Record of Decision
Lyndonville West Avenue Site
Village of Lyndonville, Orleans County, New York
Site Number 8-37-002

March 2004

DECLARATION STATEMENT - RECORD OF DECISION

Lyndonville West Avenue Inactive Hazardous Waste Disposal Site Village of Lyndonville, Orleans County New York Site No. 8-37-002

Figure 10
Lyndonville West Avenue
RAA3

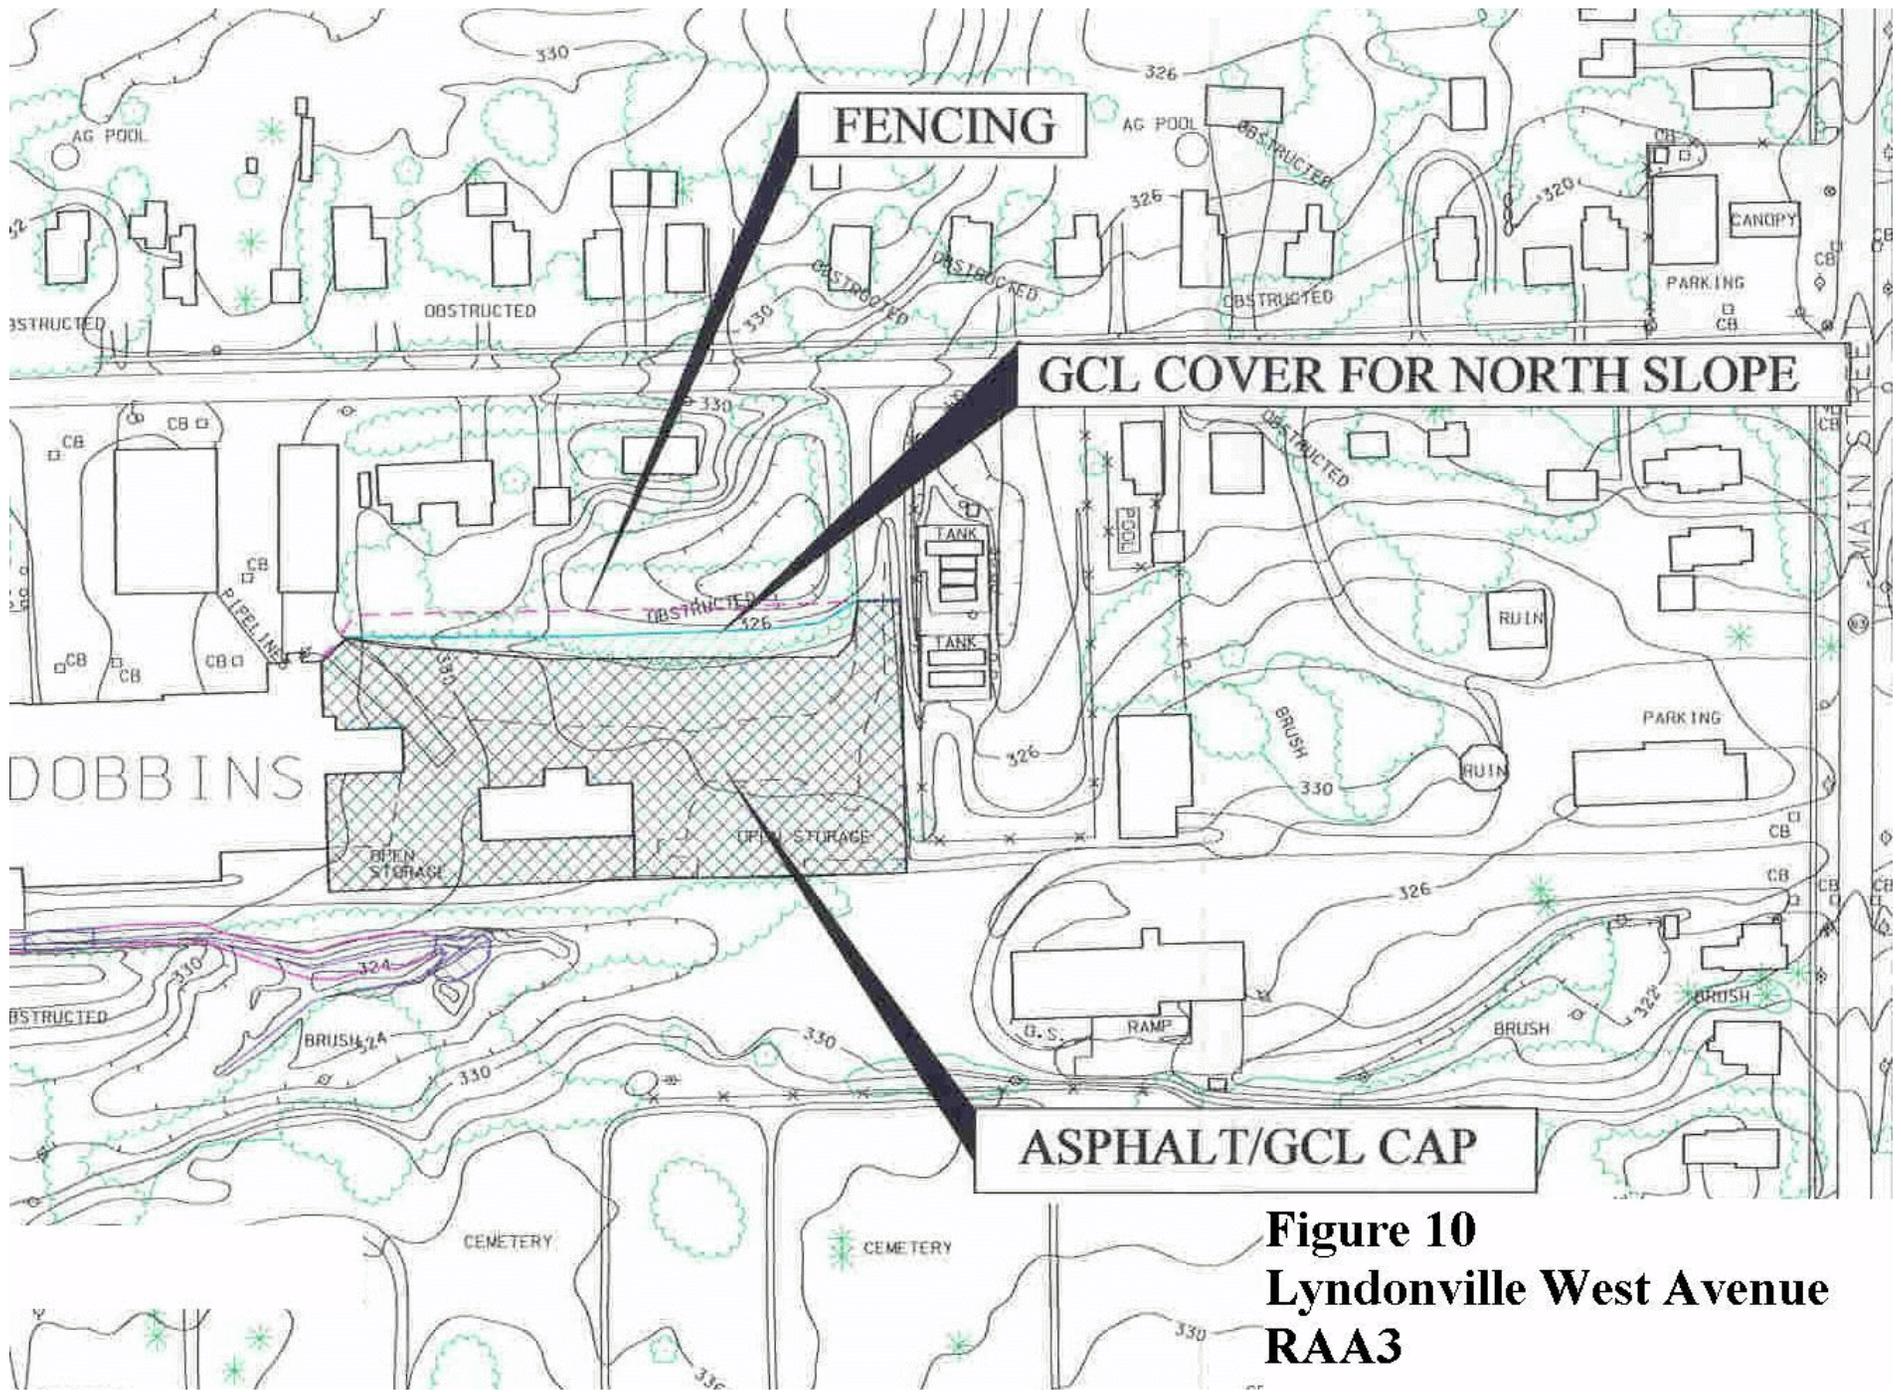
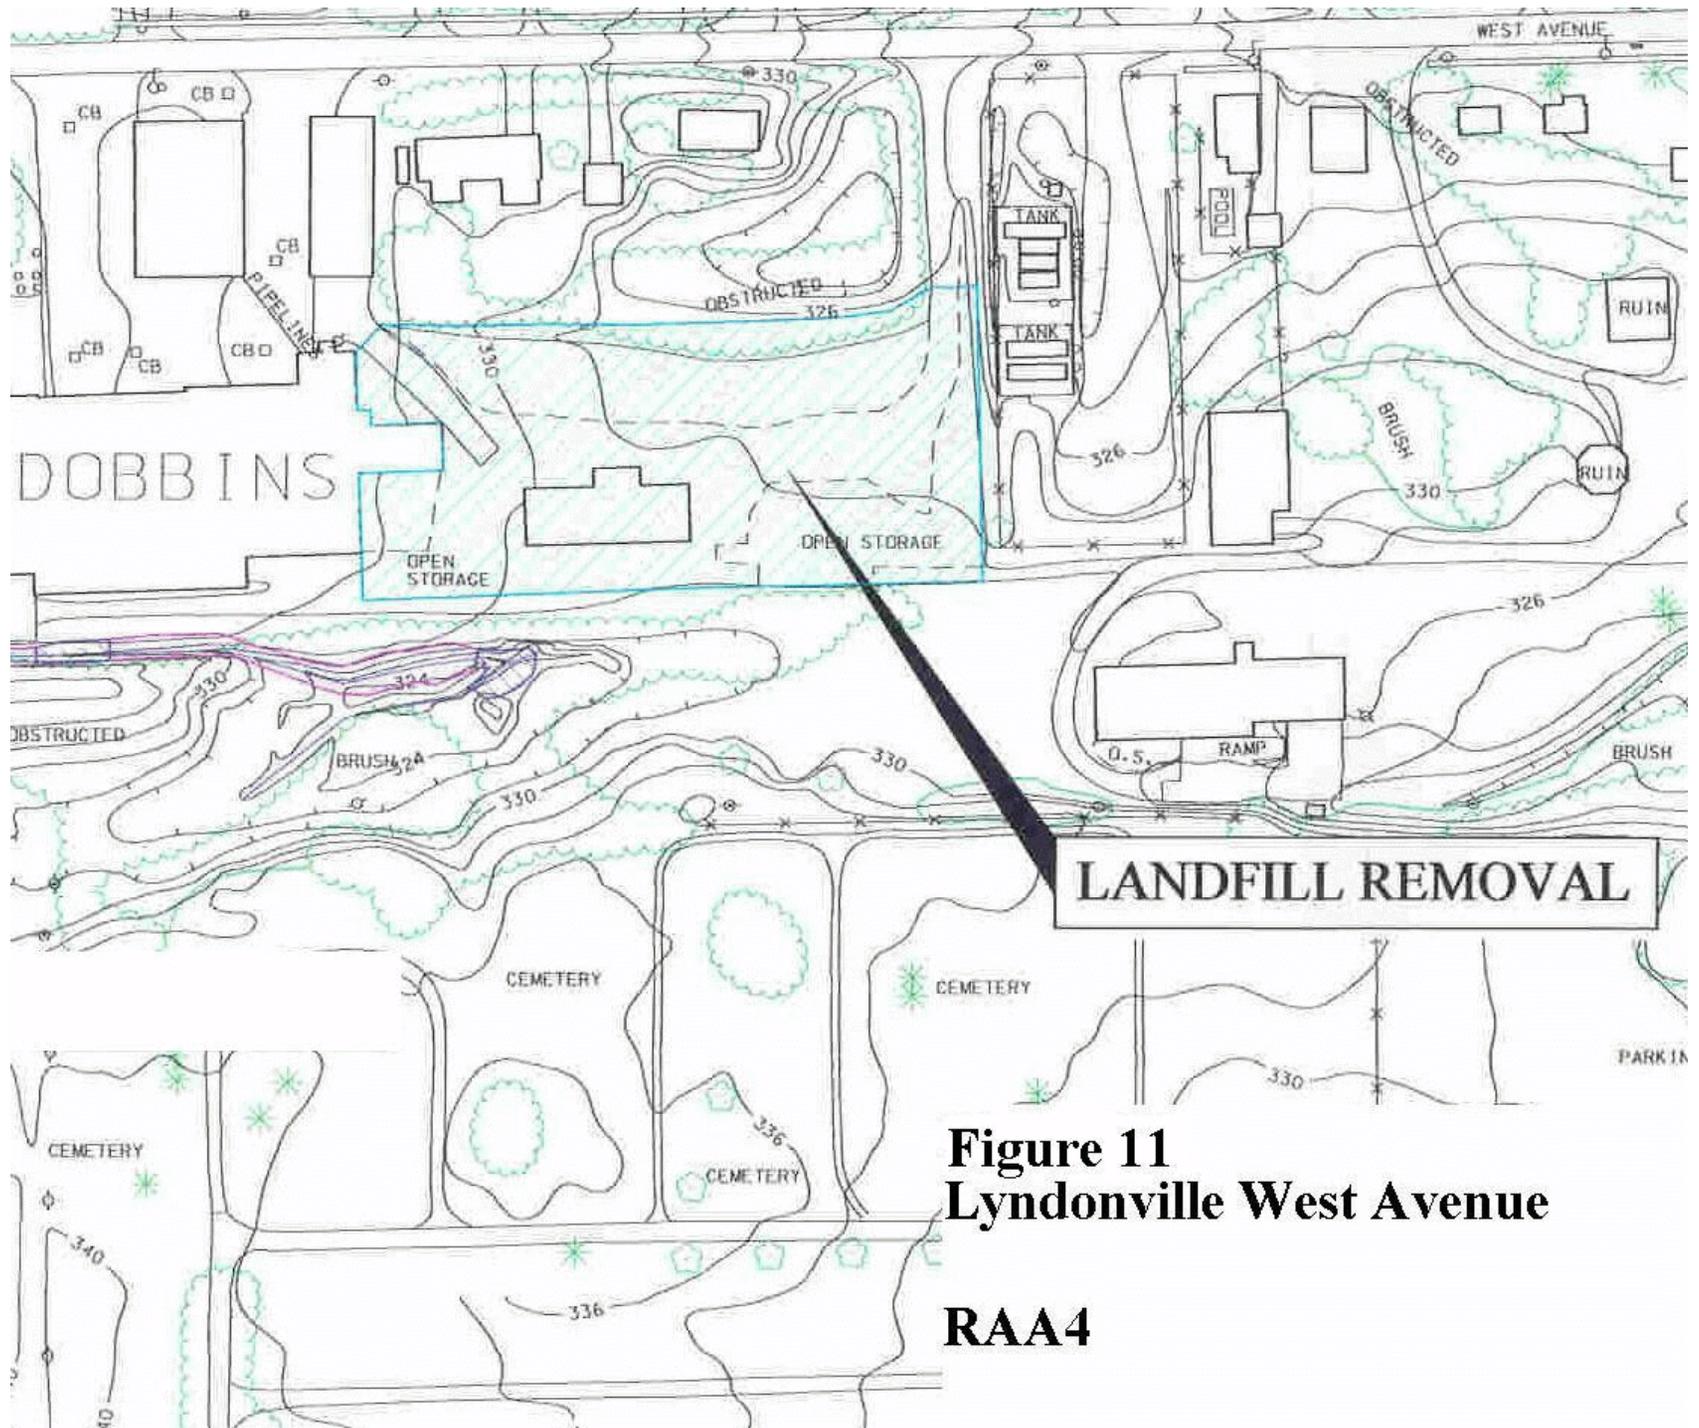
Comment 21: On page 11, plan 2 & 3-- will both plans make the site safe? Do both plans keep the water out of the site? Is Plan 3 insurance upon insurance?

Comment 28: As NYSDEC states (Section 8, fourth paragraph), "All of the remedial action alternatives except no action are protective of human health and the environment and meet the remedial action objectives for the site". DuPont believes that RAA2 is the most appropriate remedial alternative to meet the remedial action objectives for the site.

Comment 31: RAA2 and RAA3 can each be implemented within a construction season, and are both protective of human health and the environment and meet remedial action objectives for the site. The estimated additional 2 months to implement RAA3 over RAA2 may have large negative cost implications for the ongoing operation of the current business operation at the site. This should be considered in selecting the final remedial action for the landfill.

Response 21: The comment refers to the alternative with an asphalt cap verses a GCL cap with asphalt covering the GCL. As stated in the ROD, both alternatives would keep the water out of the landfill; however, the GCL cap is less prone to cracking and is better protected than an asphalt-only cap. The NYSDEC feels the GCL cap is preferable.

Response 28: As discussed in Response 21 above, the GCL cap would be less prone to cracking and is better protected than an asphalt-only cap. Furthermore, inspection and maintenance of the asphalt-only cap would be hindered by the presence of numerous stored apple crates on the site. The NYSDEC believes that the GCL cap would be less prone to failure and, therefore, more appropriate for this site.

Response 31: This has been considered. The possible use of another, equivalent technology (comment 29 above) may allow for a shorter construction time. This may be decided in the design stage. However, the NYSDEC has determined that the asphalt-only cap (RAA2) is not appropriate for this site.
